Egmanton Parish Meeting

CONSULTATION REGARDING GREAT NORTH ROAD SOLAR DEVELOPMENT
Initial Response for the Planning Inspectorate

Compiled 20th September 2025
By the Egmanton Parish Meeting, Solar Sub-Committee

Figure 3.3 – Section of developers “Targeted Consultation-Figure 1 Order Limit Additions (28/04/25)”.

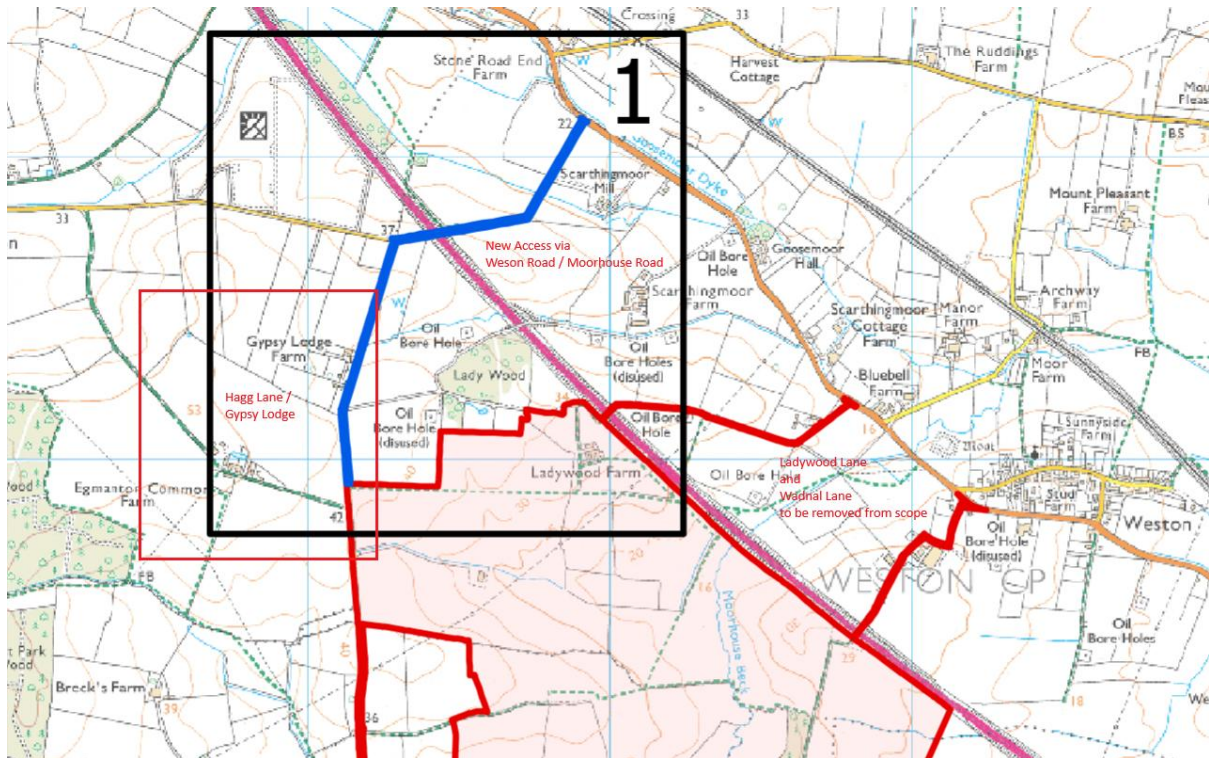
Shortly after the submission of Stage 2's consultation and receiving no response from the previous consultation, and no prior warning or offers for additional parish discussion from the developer beforehand, we were presented with the Targeted stage which removed all prior access from the B1164 Great North Road accesses in favour of the site access from Moorhouse Road as shown from the developers map below:

- The Parish objected to the planned changes.
- The parish noted that Gypsy Lodge (Now Renamed Partridge Farm) would be severely affected by traffic, being within approximately 2m of the single track Moorhouse Road.
- The parish noted that traffic into the village would be severely affected from the east.
- The parish made several suggestions (outlined in later sections) regarding alternative access.
